IMPORTANT

FORD FLYWHEELS

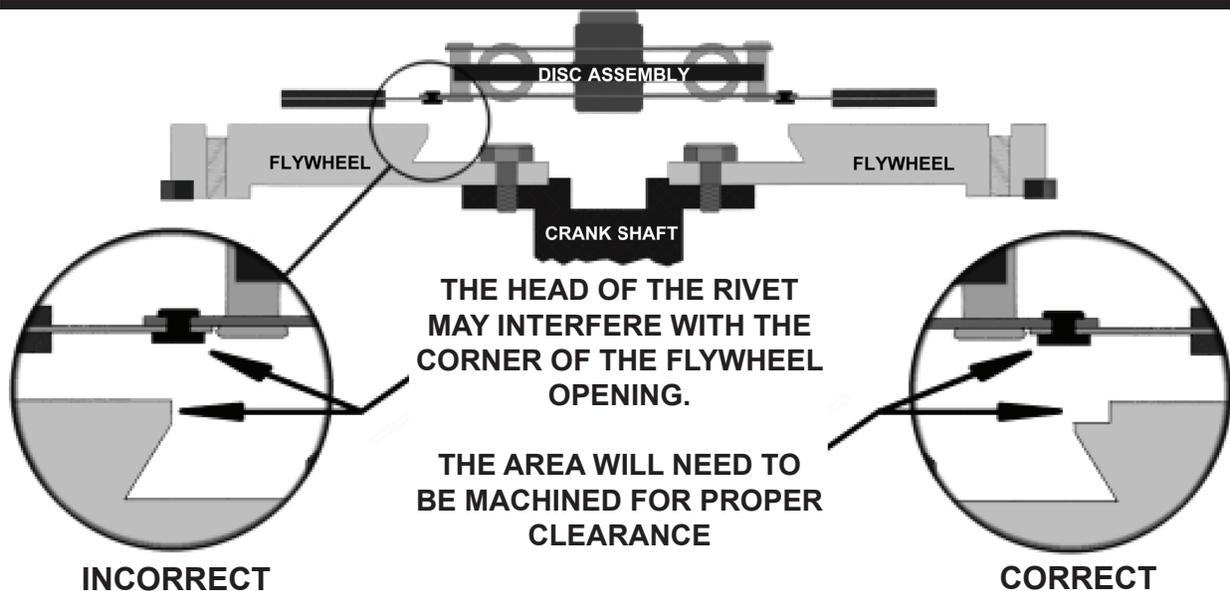
POSSIBLE INTERFERENCE MAY OCCUR BETWEEN THE CLUTCH DISC HUB TO MARCEL RIVETS DUE TO THE CENTER OPENING OF THE FLYWHEEL BEING INADEQUATE. THE RIVETS MAY RUB ON THE FACE OF THE FLYWHEEL. CAUSING THE ASSEMBLY TO RELEASE IMPROPERLY, MAKE NOISE DURING ENGAGEMENT, POSSIBLE FLYWHEEL AND DISC DAMAGE, AND/OR PREMATURE CLUTCH DISC FAILURE.

TO CORRECT THIS INTERFERENCE PROBLEM, A RELIEF MUST BE MACHINED INTO THE FLYWHEEL BY A QUALIFIED MACHINE SHOP. THE RELIEF SHOULD BE APPROXIMATELY .100" DEEP WITH SUFFICIENT DIAMETER TO CLEAR THE RIVET HEADS.
